City of Dublin Planning and Zoning Commission

Planning Report

Spa at River Ridge – Sign and Architectural Modifications

10-029CDD/CDDS
Corridor Development District/
Corridor Development District Sign
The Spa at River Ridge
6570 Riverside Drive

Existing Riverside Drive Ground Sign

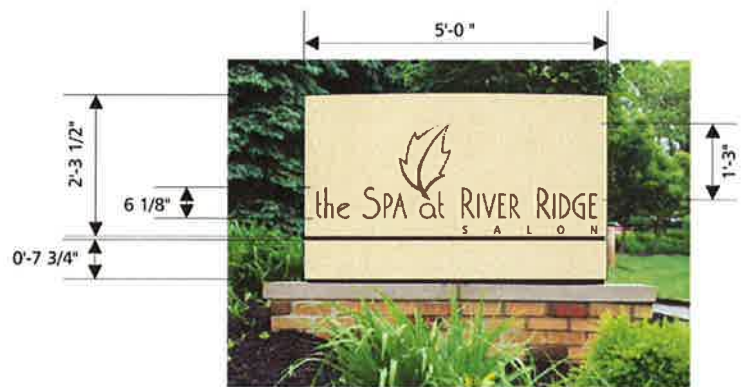
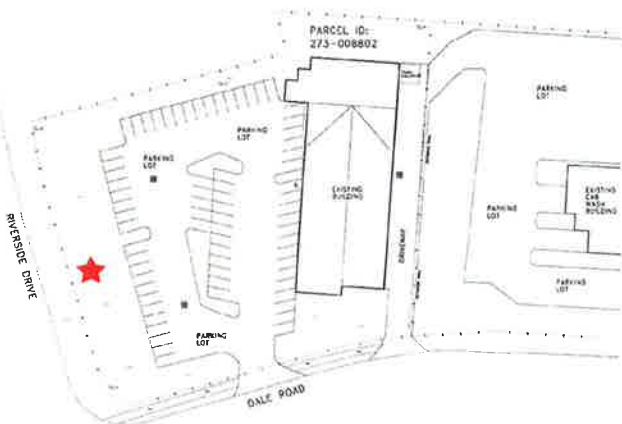
- 36.33-square-foot externally illuminated monument sign with an 18-inch brick base (existing).
- Six feet, four inches in height, located eight feet from the right-of-way (existing).
- Ten-inch sign copy that reads "The Spa at River Ridge Salon" with a two-square-foot leaf logo.
- Two colors, including "GG Earth Brown" lettering on a "GG Ivory" background.

BUILDING ELEVATION

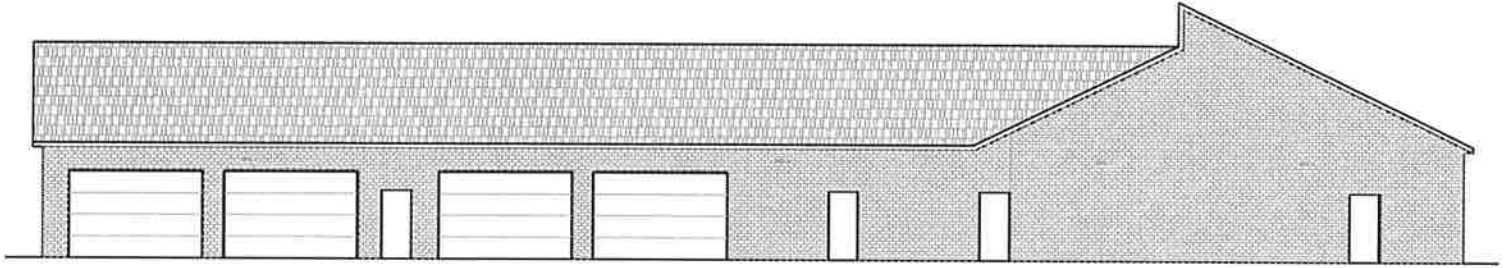
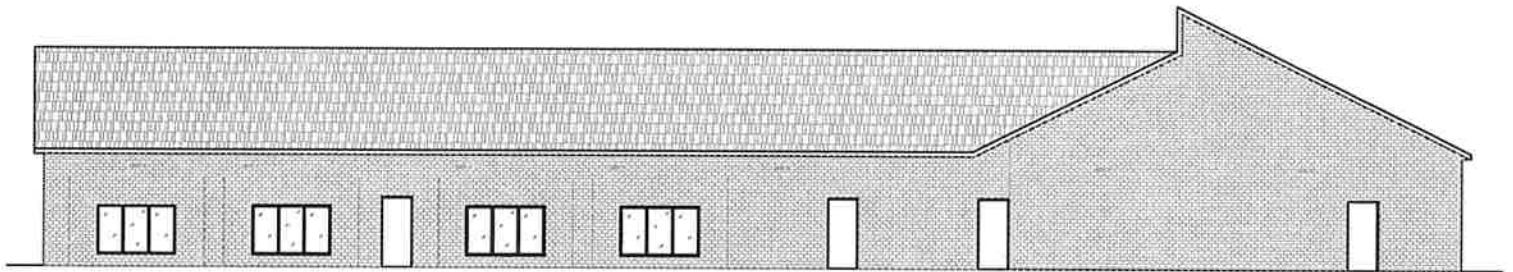
Plan Overview	<p>The proposal includes:</p> <ul style="list-style-type: none">• Architectural Modifications: Removal of four garage doors, to be replaced by brick, walls and a total of twelve casement windows.• Sign Modifications: Refacing two existing ground signs with the new tenant's information. No modifications are proposed to the sign height, dimensions, or landscaping.
Architecture	<p>The applicant is proposing to replace four existing garage doors with light brown brick, matching the existing brick. The applicant is also proposing to install a total of twelve 36-inch by 60-inch fixed casement windows with aluminum cladding and tempered clear glass to allow natural light to enter the building.</p>

- 2) The proposal is consistent with approved plans for the area.
Criterion met: *This proposal meets the requirements of the Zoning Code.*
- 3) The proposal is in keeping with the existing and future land use character of the area.
Criterion met: *The proposal is for minor architectural modifications which include the conversion of existing garage doors to coordinating brick and storefront windows that will enhance the appearance of the east elevation of the existing building.*

- 4) Meets or exceeds design and development standards, including site design, architecture, and signs.
Criterion met: *The proposed architectural modifications are consistent with the character of the existing building and adjacent development. The proposed signs meet all Zoning Code standards.*

It is Planning's opinion that the proposed signs and architectural modifications are consistent with the Zoning Code and with existing development in the area, and approval is recommended.

Existing Dale Drive Ground Sign

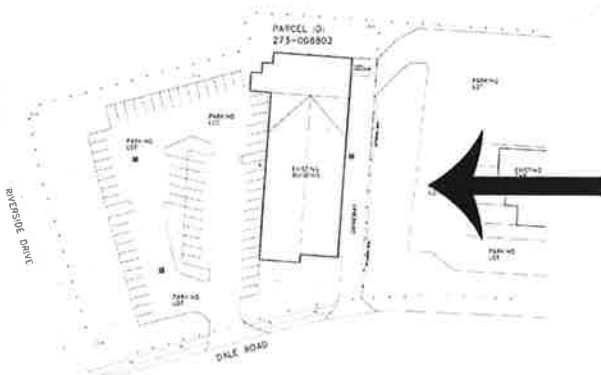
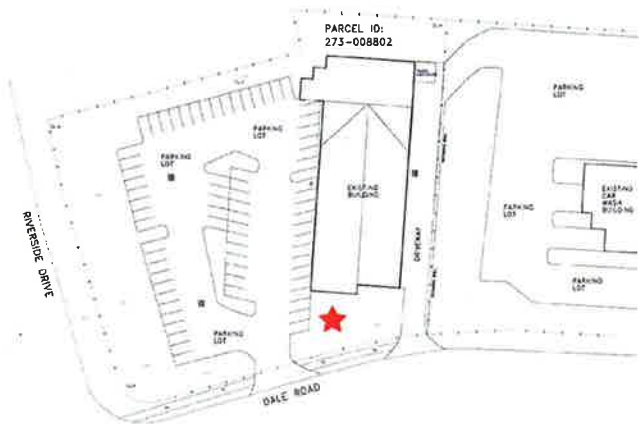
- 14.68-square-foot externally illuminated monument sign with an 18-inch brick base.
- Four and a half feet in height, located eight feet from the right-of-way.
- Six-inch sign copy that reads "The Spa at River Ridge Salon" with a 1.25-square-foot leaf logo.
- Two colors, including "GG Earth Brown" lettering on a "GG Ivory" background.
